Site Plan Review Committee (SPRC)

Staff Report for

RiverHouse

[REZN22-00007](#) (Rezoning)

Typical Proposed S. Joyce St. (Little Joyce) Cross-Section
(Looking North)

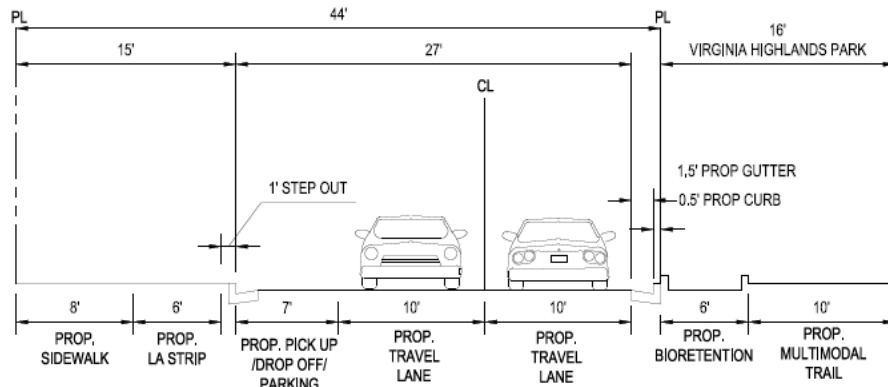
The Primary east-west Green Ribbon connection crosses Little Joyce, providing a direct path to Virginia Highlands Park. However, the proposed design, with the proposed Primary path between the new C2 and C3 buildings does not quite meet the sector plan expectations as the widest pedestrian zone. Additionally, the proposed street crossing on Little Joyce lacks both a robust biophilic design as well as engineering design at the curb ramps to fulfill the design guidelines calling for a “clear pedestrian path”.

While the proposed western streetscape provides adequate 8'-wide sidewalks, the inclusion of multiple porte-cocheres (serving the Ashley and C2 buildings), disrupts the pedestrian network and prioritizes vehicles over other modes utilizing Little Joyce. Additionally, these deviations limit the inclusion of on-street parking opportunities along this frontage.

Green Ribbon Along Southern Edge, S. Kent St., and Loop Road

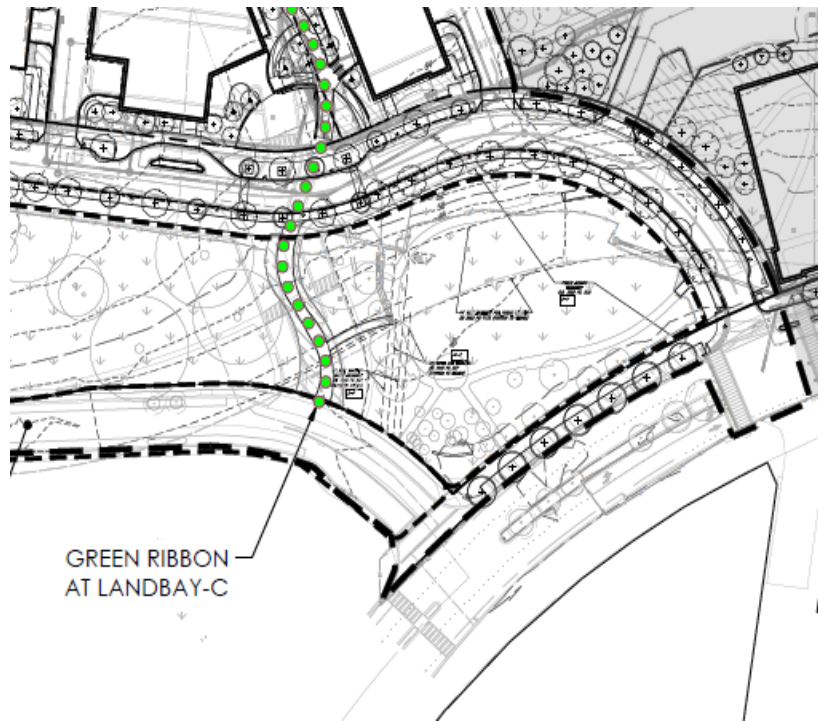
The proposed Green Ribbon aligns with the east-west portion of the Loop Road, located to the south of the proposed townhouse units and connecting the southern portion of S. Joyce St. (Little Joyce) to a path ultimately leading to S. Arlington Ridge Rd. to the west. The Green Ribbon further follows the new S. Kent Street alignment, continuing further north to Land Bay N as well as to the west, connecting to 15th St. South, following a set of switchbacks to account for the existing steep grades. The intersection of the Green Ribbon at this juncture, however, should be further refined to minimize street crossings, and to maximize the pedestrian infrastructure widths. This area needs further design to maximize its potential utility in fulfilling the vision of the Sector Plan.
